IEEE P802.15
Wireless Personal Area Networks

Project	IEEE P802.15 Working Group for Wireless Personal Area Networks (WPANs)	
Title	TG3 D10 running comment resolutions	
Date Submitted	[8 July, 2002]	
Source	[James P. K. Gilb] [Apparent Technologies] [9921 Carmel Mountain Rd. #247, San Diego, CA 92129]	Voice: [858-538-3903] Fax: [858-538-3903] E-mail: [gilb@ieee.org]
Re:	[]	
Abstract	[This document is a record of comment resolutions for LB17.]	
Purpose	[To provide a record of the comment resolution for LB17.]	
Notice	This document has been prepared to assist the IEEE P802.15. It is offered as a basis for discussion and is not binding on the contributing individual(s) or organization(s). The material in this document is subject to change in form and content after further study. The contributor(s) reserve(s) the right to add, amend or withdraw material contained herein.	
Release	The contributor acknowledges and accepts that this contribution becomes the property of IEEE and may be made publicly available by P802.15.

1. Comment resolution, Vancouver to Schaumburg

Figure 1—MSC for the initiating of a neighbor piconet.

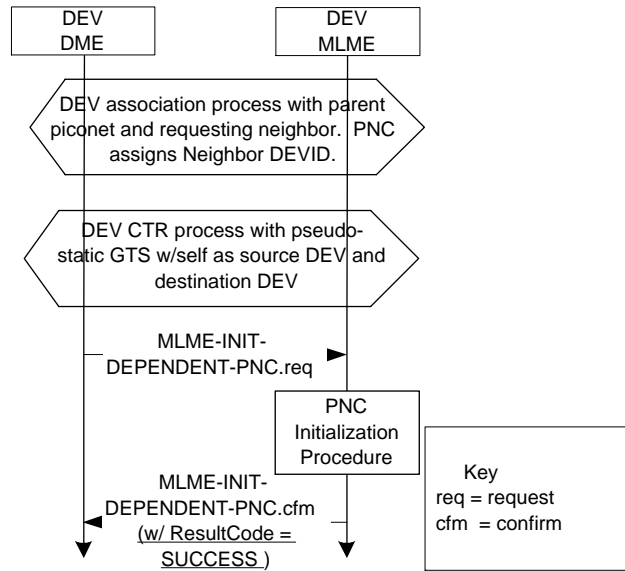
179 (Heberling, TR) - Figure 98 should be replaced with a proper MSC of the required protocol needed to establish a neighbor piconet. Replace figure 98 with a proper MSC. **Suggest accept** - An MSC for neighbor piconet initialization is included below. It needs twiddling to get the vertical lines to not show in the hex pro-

cess blocks. Also, although consistent with other similar diagrams, this MSC seems to need the first beacon of the neighbor PNC shown.

The MSC for the initiation of the neighbor piconet is illustrated in Figure 4.

Figure 3—MSC for the creating a child piconet.

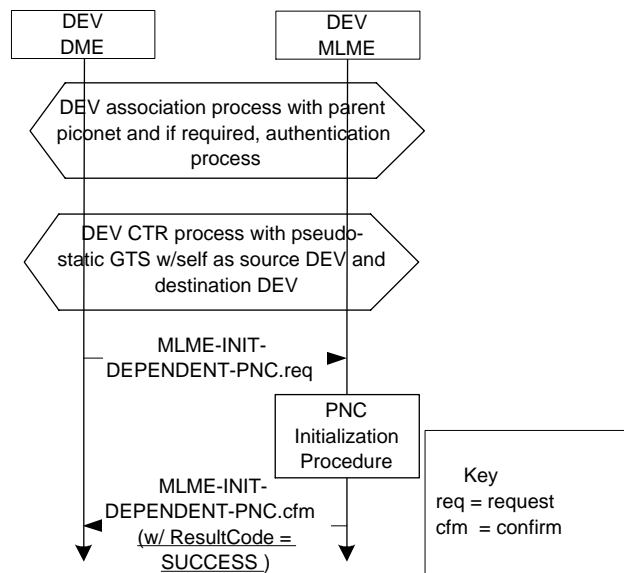
177 (Heberling, TR) - Figure 96 should be replaced with a proper MSC of the required protocol needed to establish a child piconet. Replace figure 96 with a proper MSC. **Suggest accept** ‘An MSC for child piconet initialization is included below. It needs twiddling to get the vertical lines to not show in the hex process blocks. Also, although consistent with other similar diagrams, this MSC seems to need the first beacon of the child PNC shown.

Accept suggested resolution but add a line at the bottom that shows the first beacon being sent. Also add after the sentence that says 'The MSC for creating a child piconet is illustrated in Figure 2.' the following sentence, 'The association and channel time request processes are defined in xref and xref, respectively.'

Figure 4—MSC for a approved asynchronous channel time request

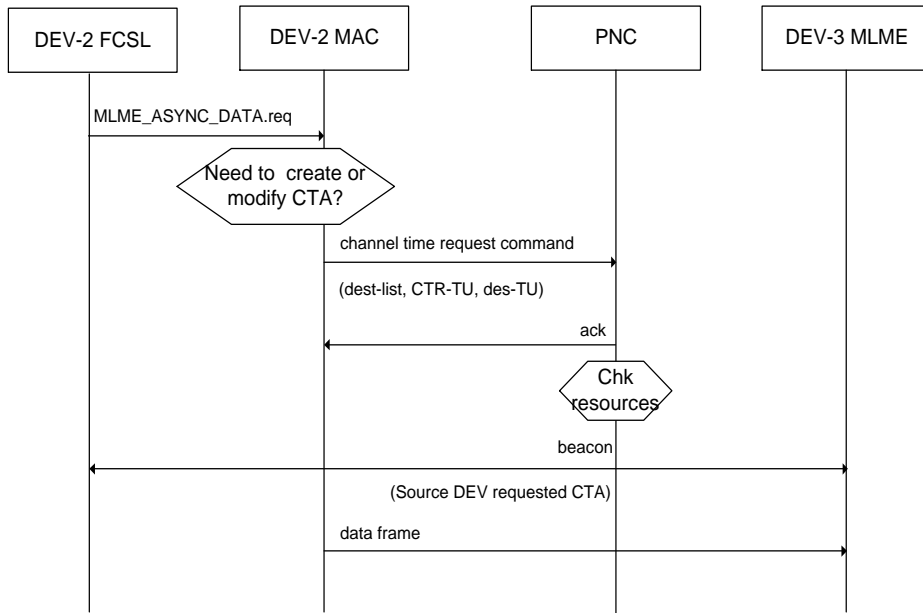
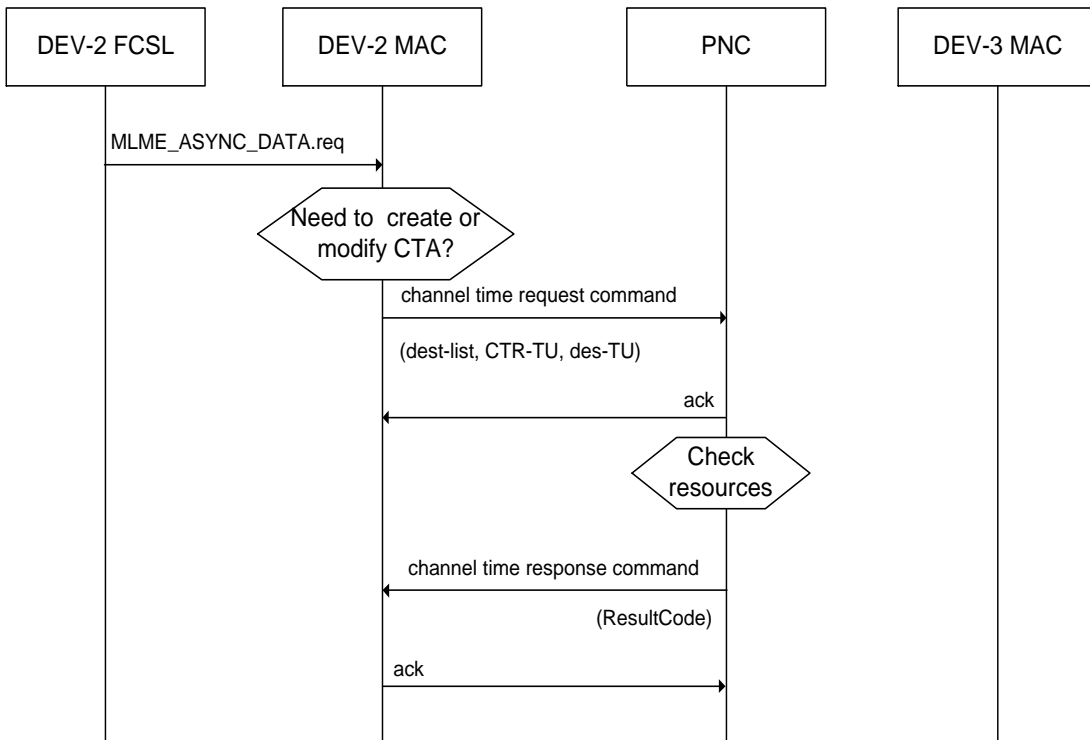
327 (Heberling, TR) Figure 119 is a flawed MSC of the Asynchronous channel time reservation process and data frame exchange. Consequently, delete the current MSC from this section of clause 8.5.2.1 and replace it with 02r0P802-15_TG3-Asynch-channel-time-allocation.eps. **Suggest accept.**

Figure 119 – MSC for reserving asynchronous data channel time. Discussed earlier, new MSC is below:
